HILLVIEW SUBDIVISION, BLOCK 2, RESUBDIVISION OF LOT 5

APPLICATION NUMBER Holdover DATE October 16, 2003

REQUEST Subdivision

HILLVIEW SUBDIVISION, BLOCK2, RESUBDIVISION OF LOT 5

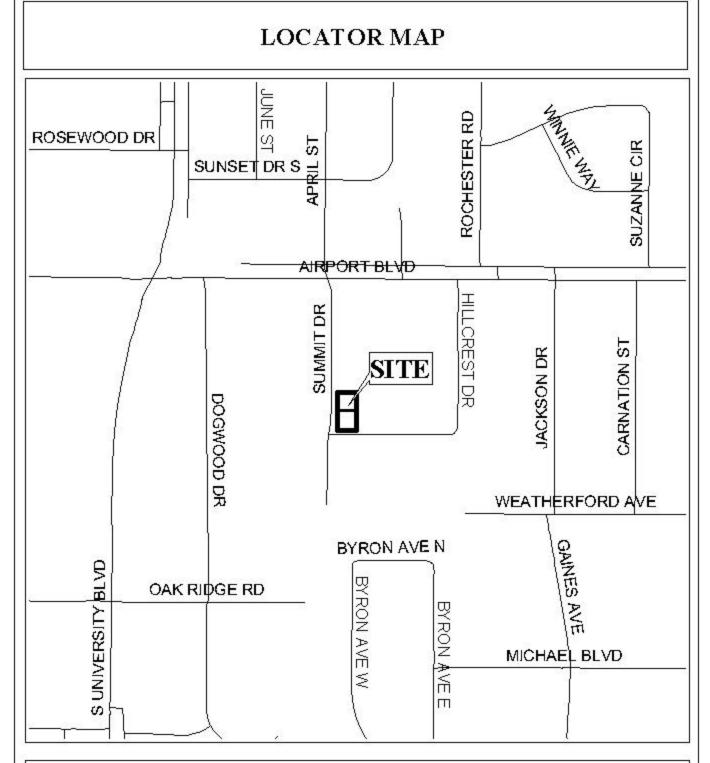
As illustrated on the Vicinity Map, a structure seems to be constructed near the proposed property line, thus creating a zoning violation. The Zoning Ordinance requires a minimum eight-foot side yard setback and eight-foot rear yard setback; therefore, it should be illustrated on the final plat that the existing structure be removed or provide the minimum setback requirement of eight-foot along the property line.

The plat meets the minimum requirements of the Subdivision Regulations and is recommended for Tentative Approval subject to the following conditions 1) the placement of a note on the final plat stating that with Lot 2 being a corner lot, the dedication of a 25' radius should be required; and 2) the illustration on the final plat that the existing structure on Lot 2 is setback a minimum of eight-foot from the proposed property line and a minimum of eight-foot from the rear property line or the removal of the structure prior to the recording of the final plat.
